Report to Planning applications committee

Subject Application no 15/01480/VC - Depository Building Part
Lion House and Part Seymour House, Muspole Street,
Norwich

Development proposal		
Removal of Condition 2 to remove the phasing element of the approved scheme; amendments to the wording of Conditions 3-10 and 15-20; and variation of Condition 21 to allow for minor changes to the approved plans of planning permission 12/00143/ET.		
Representations		
Object	Comment	Support
2

East Elevation on to Muspole Street - S73 Amendments

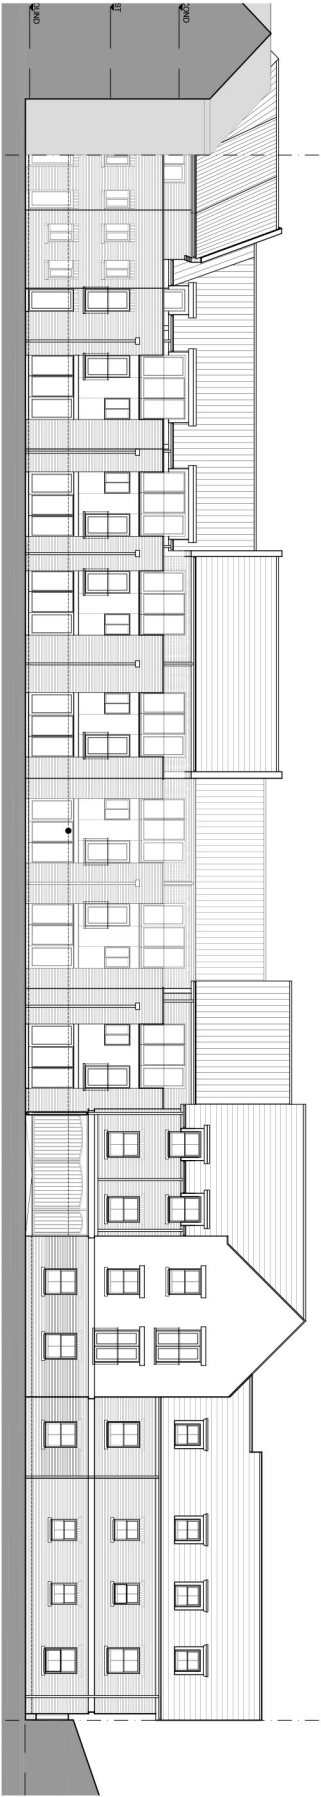
22. The currently approved scheme does not have the required 3.7m and so the bridge link section needs to be raised. To achieve this the drawings originally submitted created a visually discordant gap within the terrace, particularly given the misaligned fenestration. Several revisions were sought to minimise the visual harm, including redesigning the windows and dormers to ensure greater consistency with the adjacent row. While this is not as visually optimal as the original scheme, a 3D model of the original scheme and the alternatives was submitted. Being overlaid on a satellite image of Muspole Street it was possible to see that given the significant setback of the area in question from the rest of the terrace, that the visual prominence of the feature is limited. The terrace is designed with numerous setbacks and varying ridge heights and this could be argued to be a continuation of this. Prior to these changes being agreed the applicant was asked to explore the potential use of sprinkler systems to negate the need to raise the height of the access. The justification used was the potential impact on sales values, higher

service charges through maintenance and increased safety through fire appliance access in the event of system failure. While this reasoning is not without issue, it is considered adequate given the level of visual harm is now sufficiently reduced.

West Elevation - S73 Amendments

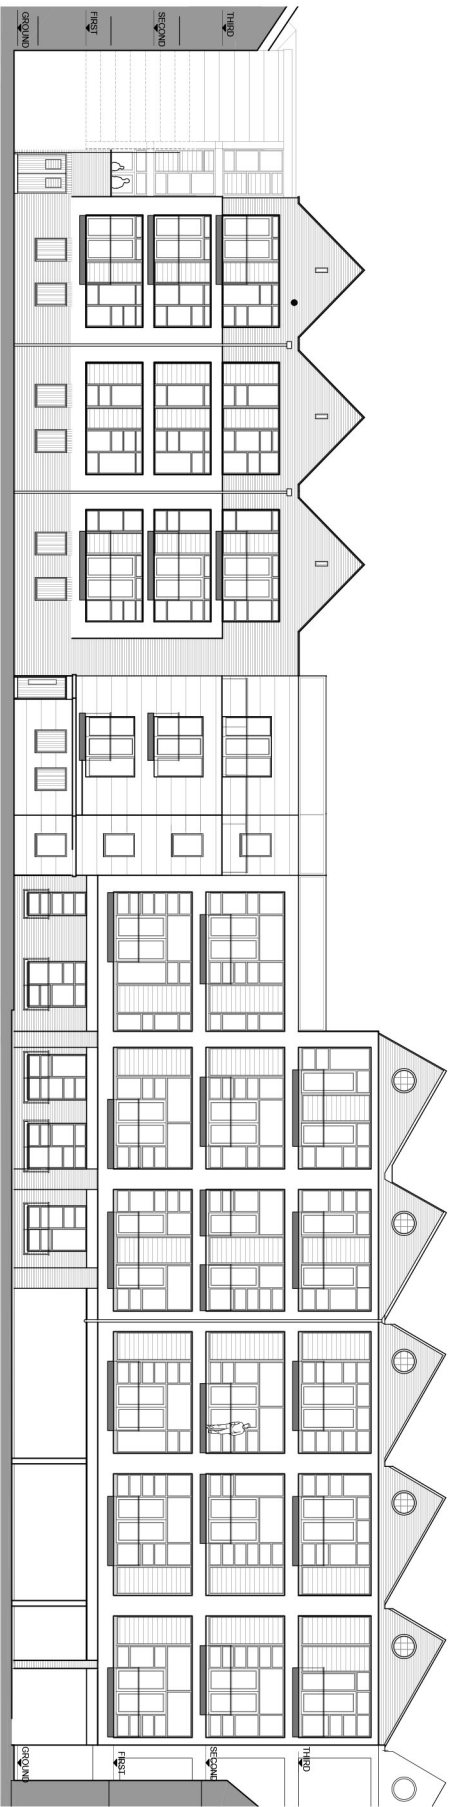
20. The design principles and overall approach to the site remain the same. While there are minor changes to the Depository building such as to fenestration and balustrading, these are largely informed by buildability considerations and are inconsequential within the grand scheme of the development. The main design changes concern the most prominent aspect: the new terrace along Muspole Street.
